AIRWORTHINESS DIRECTIVE

SUBJECT: Inspection and modification of airbrakes.

Subject : Airbrakes

Subject : Airbrakes

DETAIL X - SCALE 1 : 1

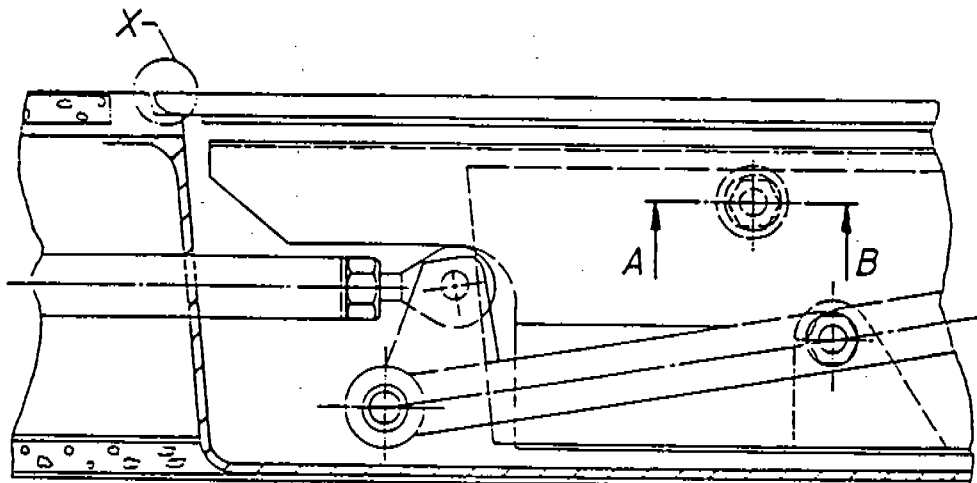
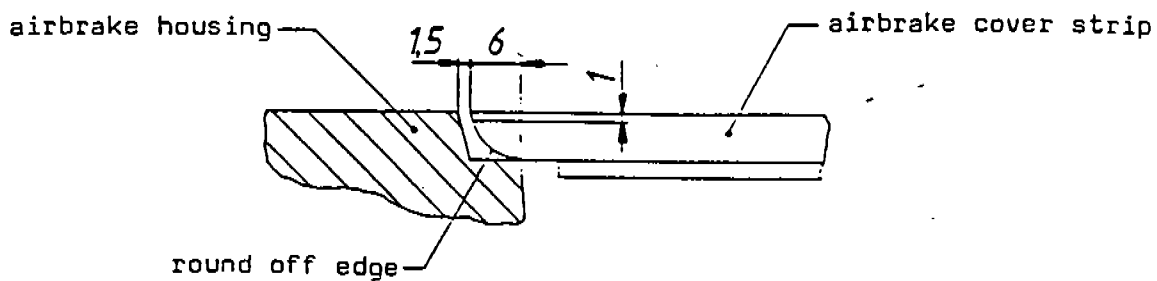
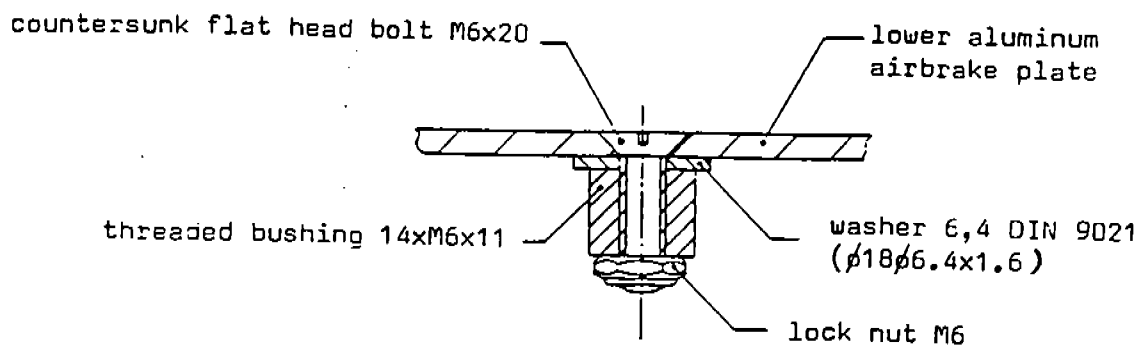
2. Round off the lower edge of the cover strip on the inboard end as shown on page 03.

3. If not yet accomplished, install a washer (\varnothing 18 mm/0.71 in.) between the threaded bushing and the lower airbrake plate as shown on page 03.

Actions : 1. With the sailplane rigged and airbrakes locked it must be checked that the gap on the inboard end between the end of the cover strip and the edge of the recess is at least

1.5 mm (0.06 in.).

If it is less, enlarge accordingly.

DETAIL X SCALE 1 : 1

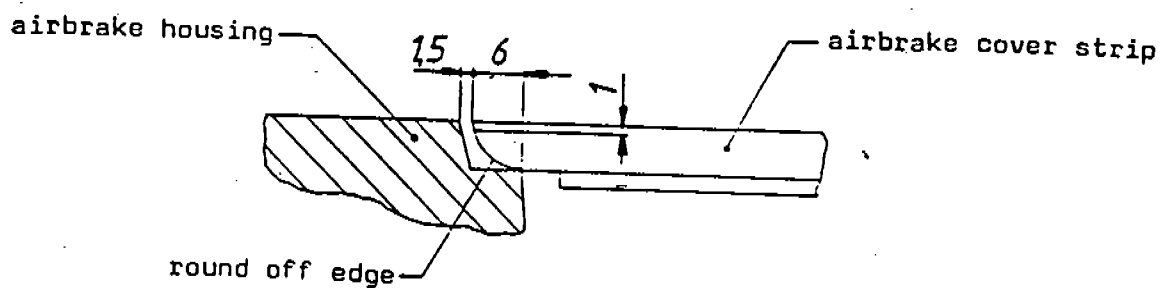
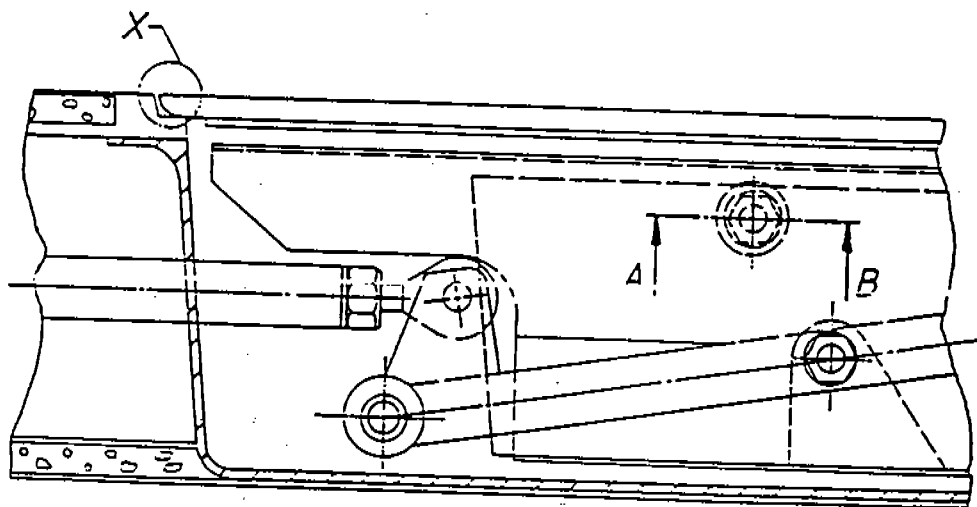
If it is less, enlarge accordingly.
2. Round off the lower edge of the cover strip
on the inboard end as shown on page 03.
3. If not yet accomplished, install a washer
(\varnothing 18 mm/0.71 in.) between the threaded
bushing and the lower airbrake plate as
shown on page 03.
4. With the powered sailplane rigged (wing tip
extensions removed) and airbrakes locked,
check for proper function of the latter:

1. With the powered sailplane rigged and airbrakes
locked it must be checked that the gap on the
inboard end between the end of the cover strip
and the edge of the recess is at least

1.5 mm (0.06 in.).
